BMP NUMBER: MC005

CUSTOM BUILDER SUPPLY
 DRAINAGE AREA MAP
 FOR
JOHN TYLER INVESTMENT GROUP
 VIRGINIA
 JAMES CITY COUNTY

CUSTOM BUILDER SUPPLY
SITE PLAN FOR STORAGE RACKS, SHEDS AND LOADING RAMP
FOR
JOHN TYLER INVESTMENT GROUP
JAMES CITY COUNTY
VIRGINIA

**CHESAPEAKE BAY NARRATIVE
FOR
CUSTOM BUILDER SUPPLY
SITE PLAN SUBMITTAL**

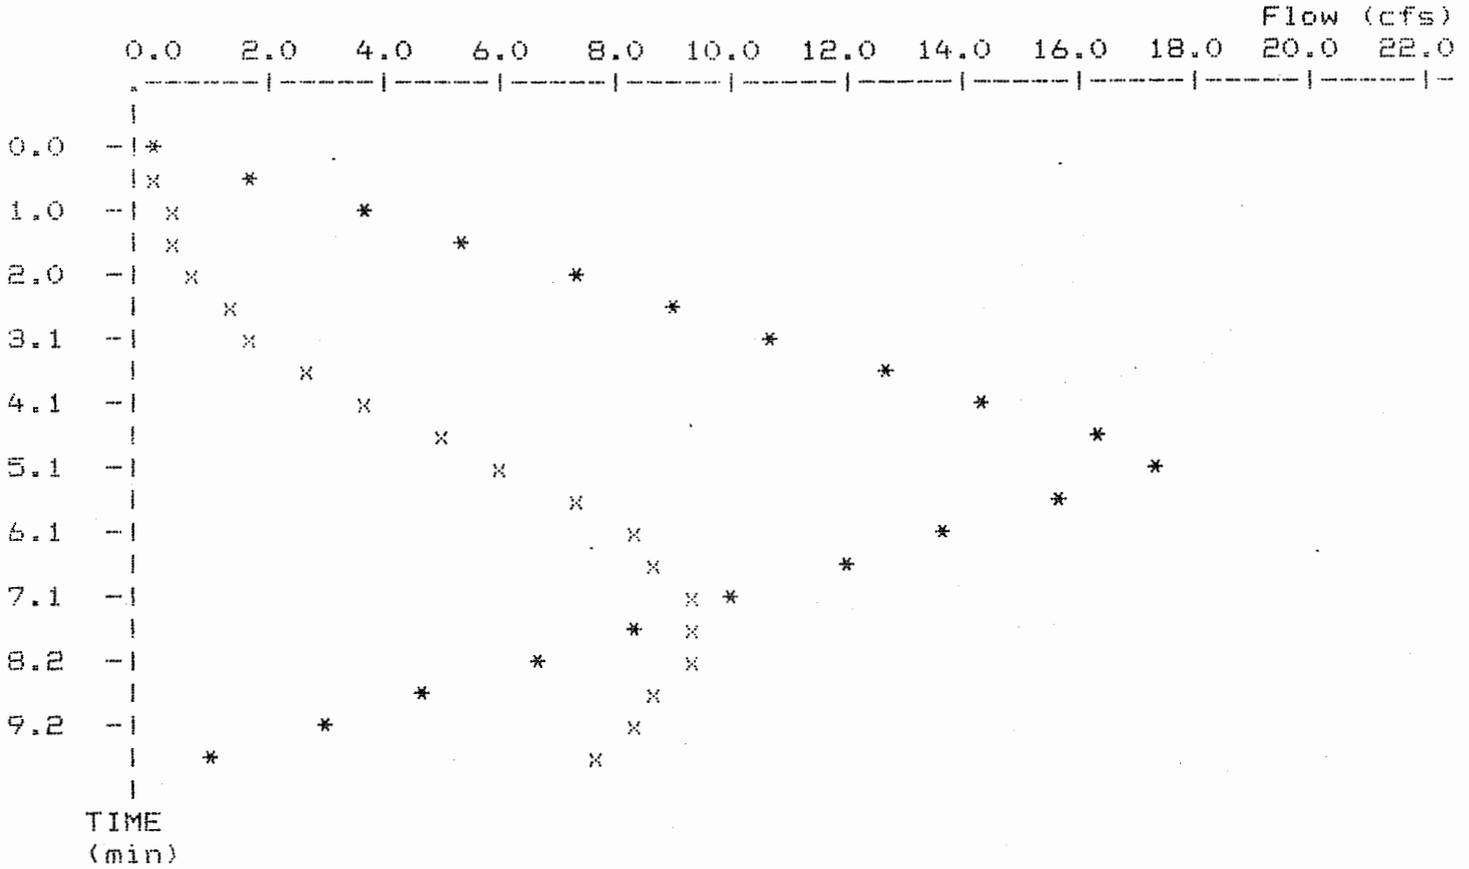
*check also 24" pipe
 to see which controls*
